County of Fairfax, Virginia

STAFF REPORT

PCA C-108 / FDPA C-108-04 / SE 2012-PR-005

APPLICANT: Arlington Boulevard Development, LLC

Figure 6 – Conceptual Rendering of Breezeway and Courtyard Area

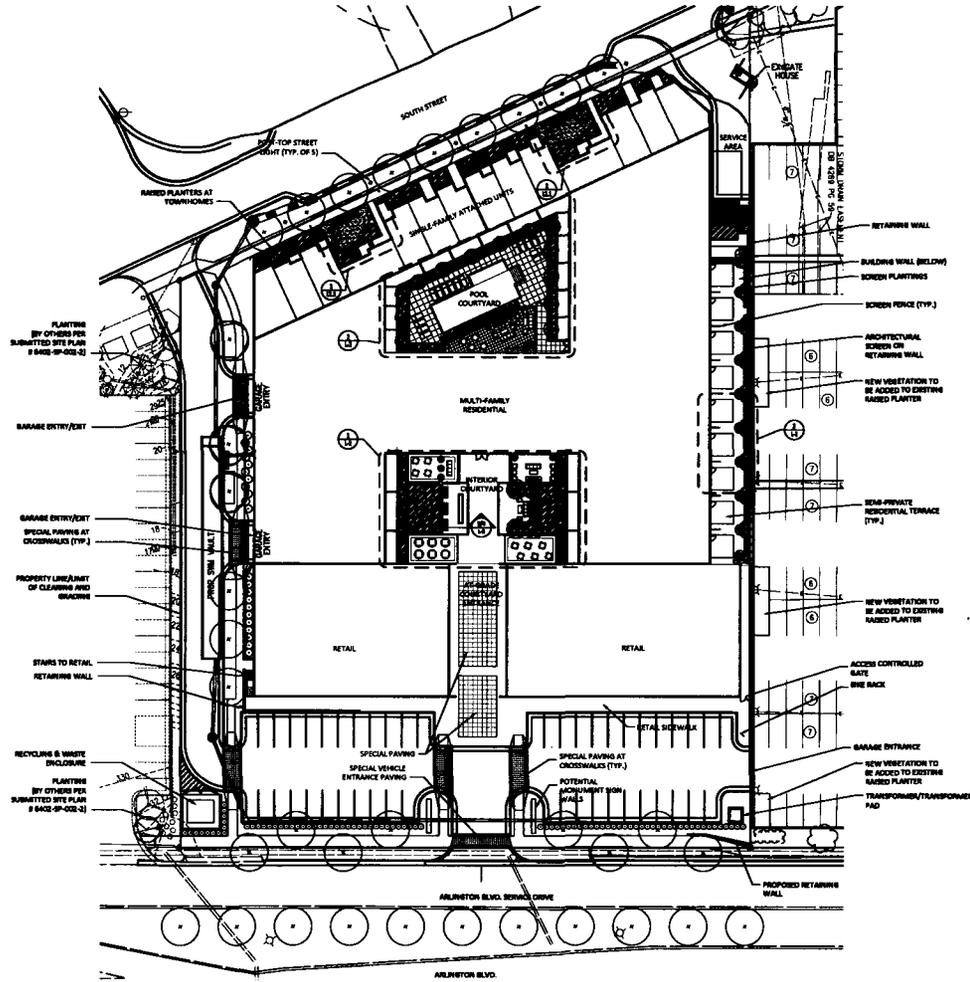
In order to avoid creating an uninviting tunnel effect, staff recommends that the applicant commit to the design of the courtyard and breezeway as depicted in the conceptual renderings (see Figure 6). The applicant has now provided a proffer to this effect that requires a minimum 50% glazing (windows) in the breezeway area.

Figure 3 – Entrance Courtyard

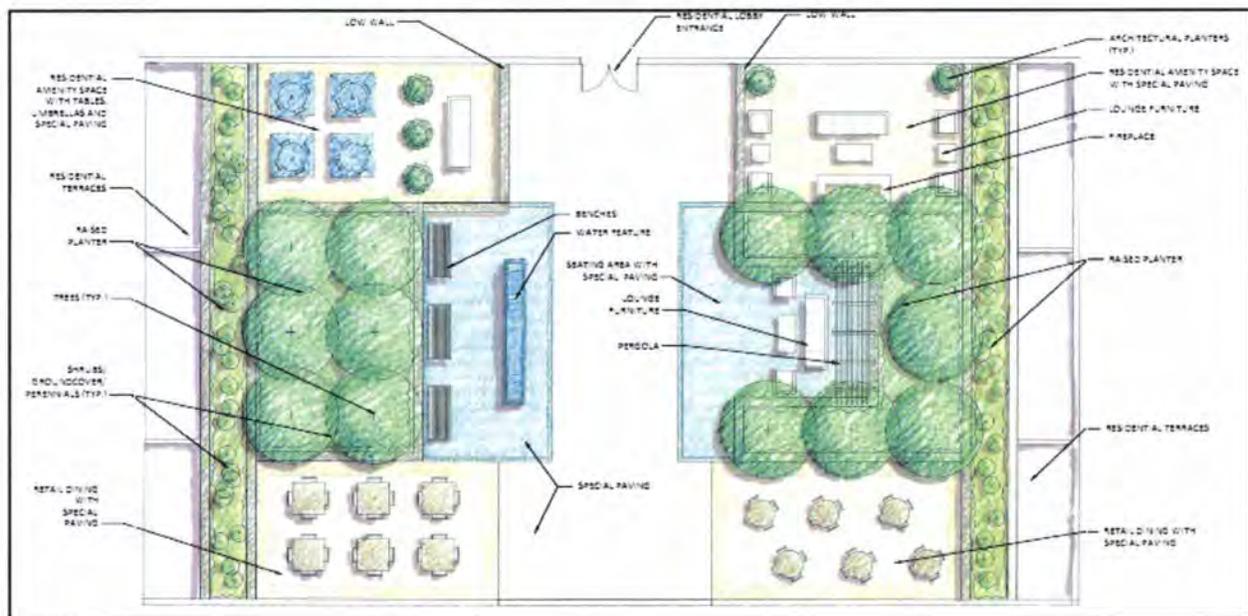
Staff is concerned that the design of the entrance courtyard will differentiate between public and private space. The applicant maintains the entire entrance courtyard will be fully open to both residents and members of the public. Similarly, staff has recommended that the pocket parks along South Street be expanded, or at a minimum, redesigned to better utilize the lawn areas and seating space. The applicant has indicated that final design of the pocket park areas will be made at site plan consistent with Sheet L-2.1 and they will investigate possible changes that could increase the utility of these spaces.
